ENGINEER'S SUPPLEMENTAL INSTRUCTIONS NO. TWELVE (12)
(Via Posting to FTP Site and Electronic Mail)

RE: Harold D. Thompson Regional Water Reclamation Facility (HDTRWRF)-Phase 1
ENGINEER'S SUPPLEMENTAL INSTRUCTIONS NO. TWELVE (ESI-012)

The ESI-012 addresses modifications to the project drawings relative to the Pumping and Disinfection Building which were issued September 16, 2011 for preparation of the CMO covering the foundation scope of work. The modifications described in this ESI appear on the Pikes Peak Regional Building Department (PPRBD) foundation only permit submittal drawings. Please distribute this ESI to any and all suppliers and subcontractors so the items described herein may be accounted for in the foundation CMO prepared for the Pumping and Disinfection Building. The following is a list of drawing modifications arranged by sheet number.

SHEET PD-6
OF —

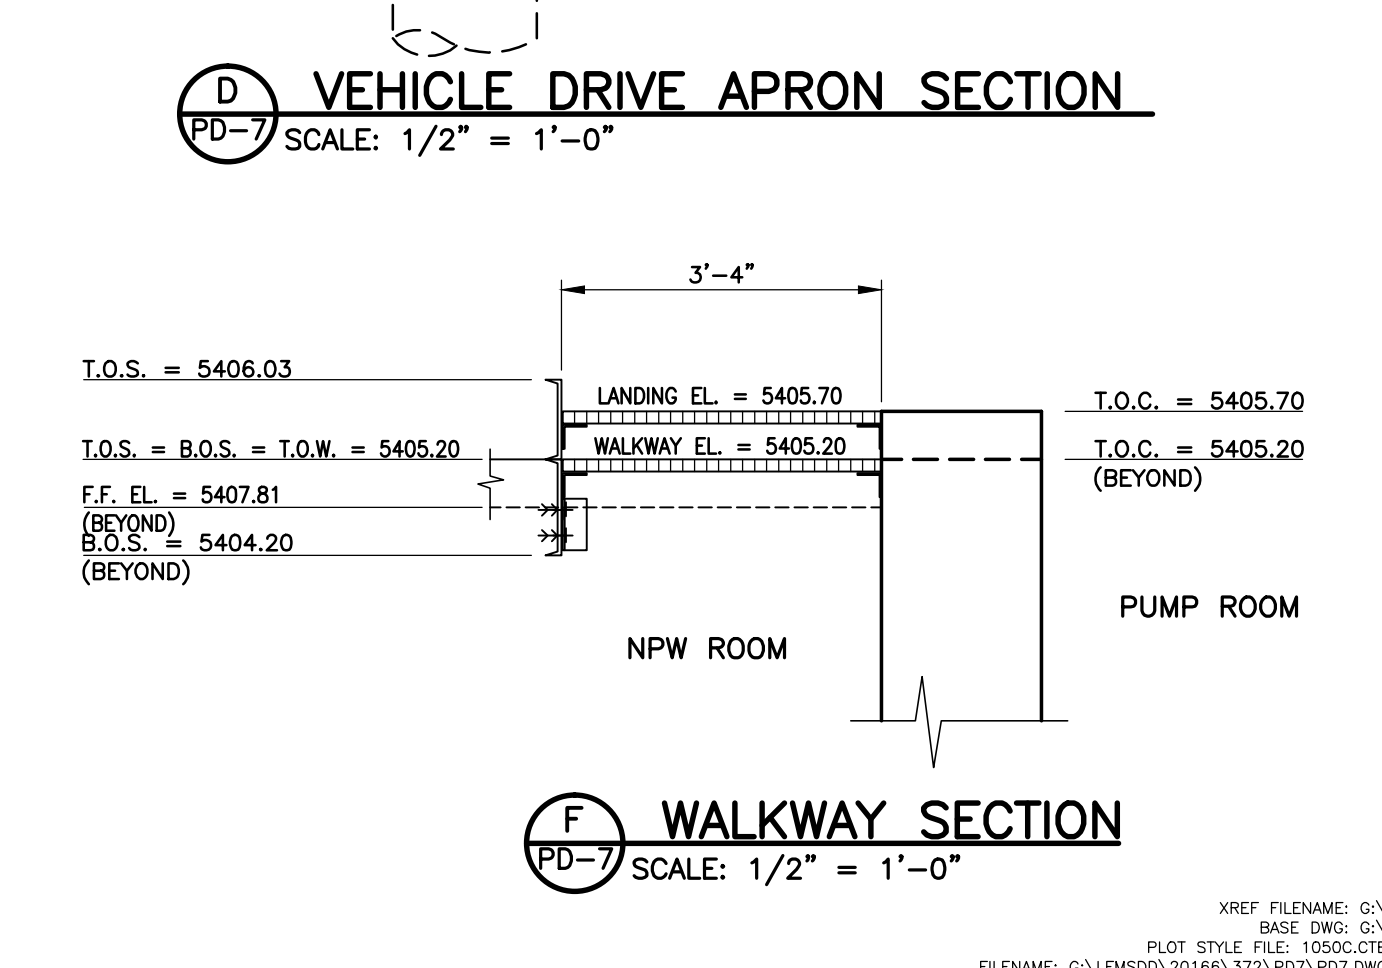
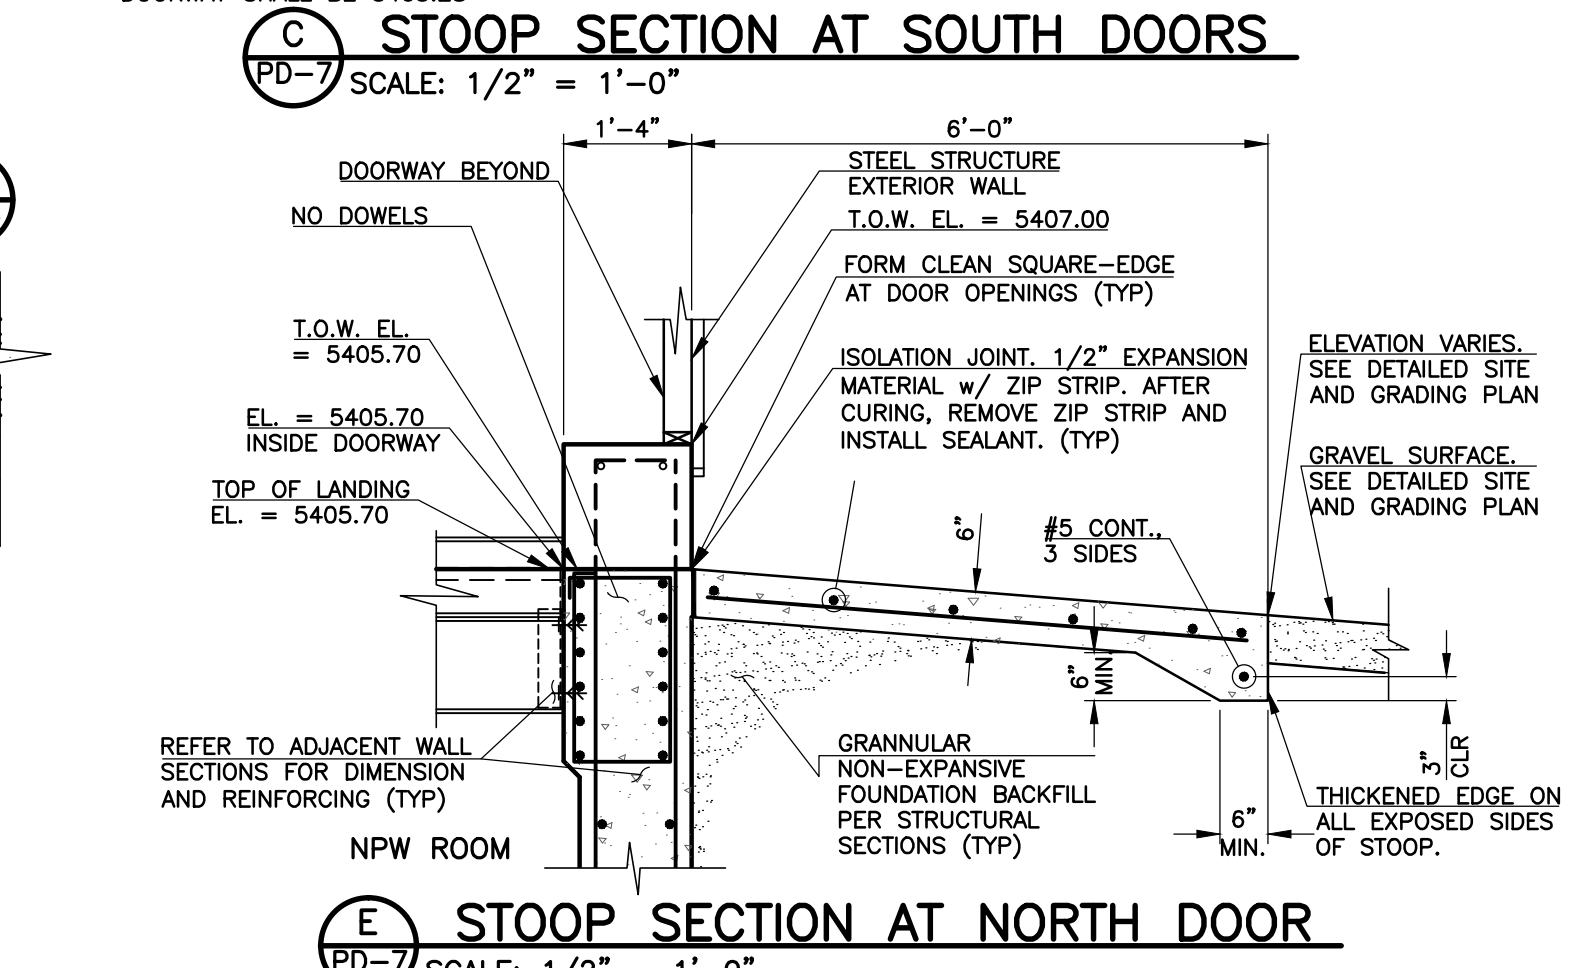
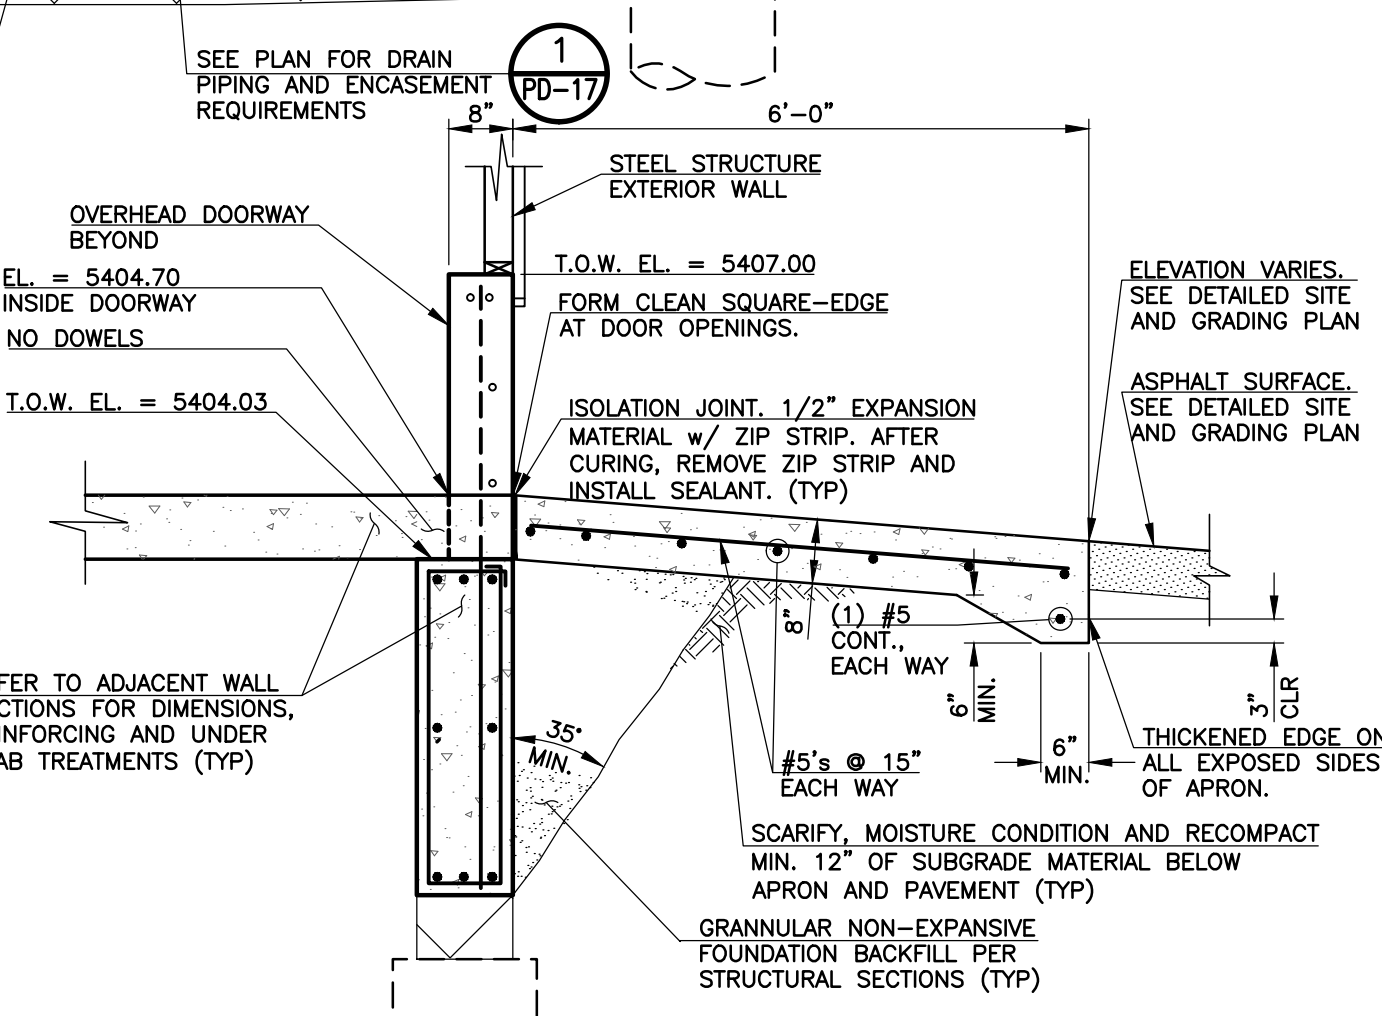
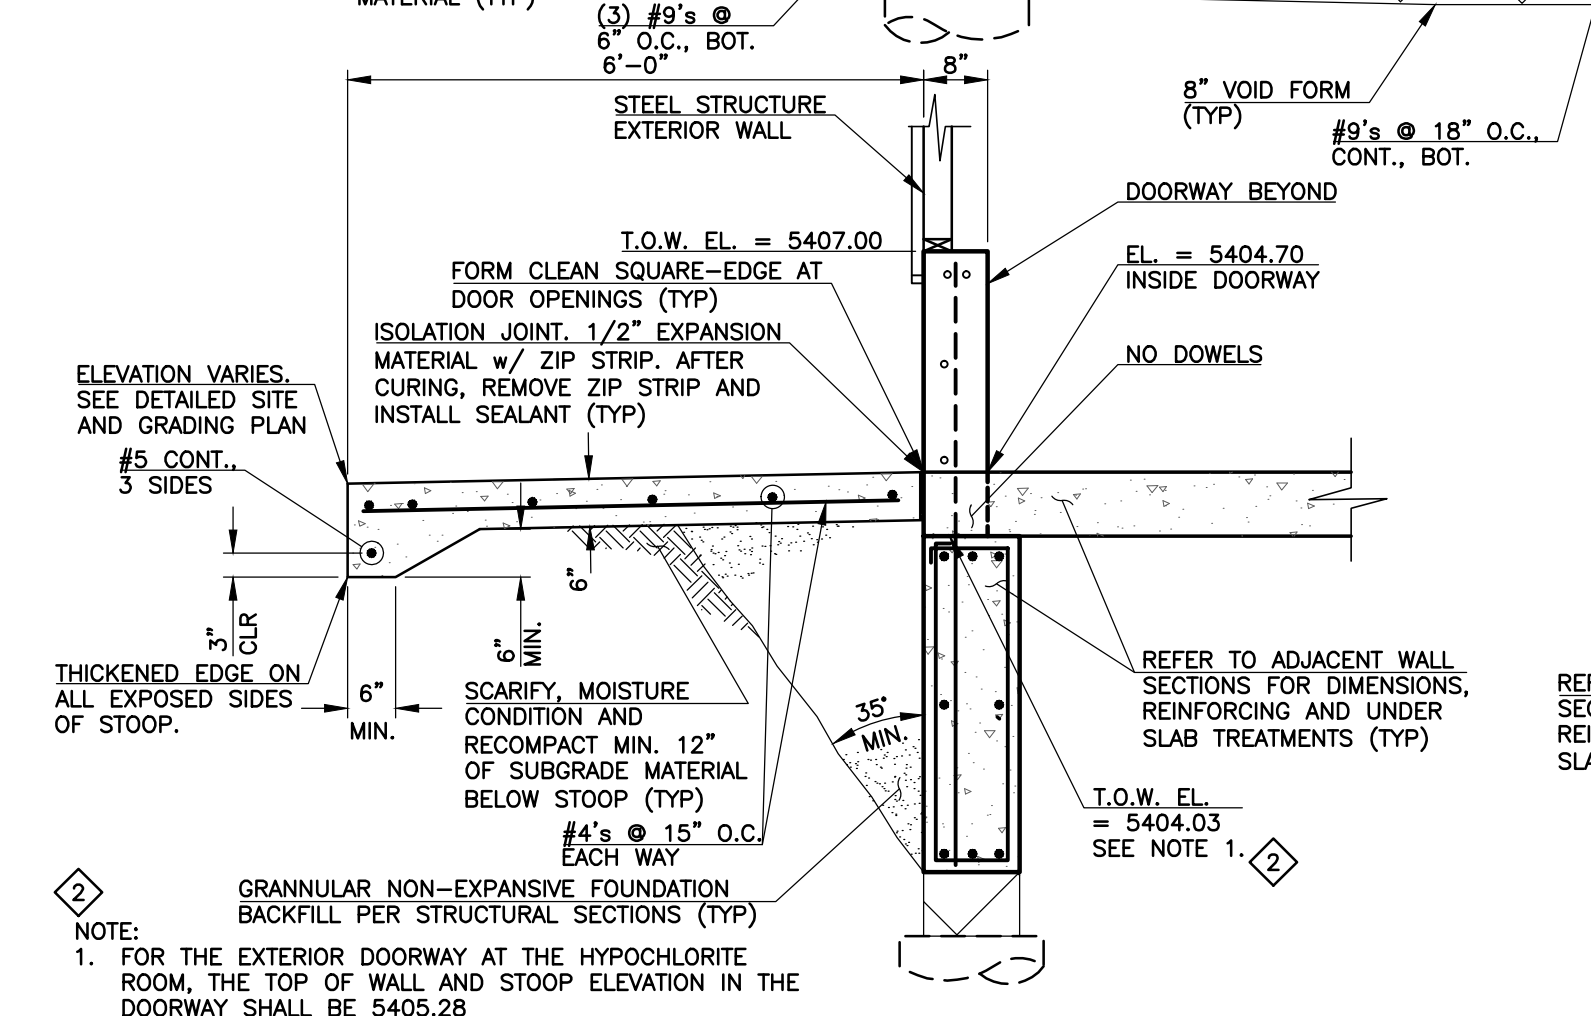
- Revised Section A to indicate the requirement of an isolation joint at the perimeter of the upper level slab
 - Revised Section A so the top of concrete elevation of the Pump Room slab outside of the trench drain will be 5386.33

- Added Sheet Note 1 to reference Sheet PD-4 and its Note Nos. 13 and 14 regarding rigid insulation requirements
- Sheet PD-7
 - Revised Section A to indicate the requirement of a tooled joint along the perimeter of the upper level floor slab
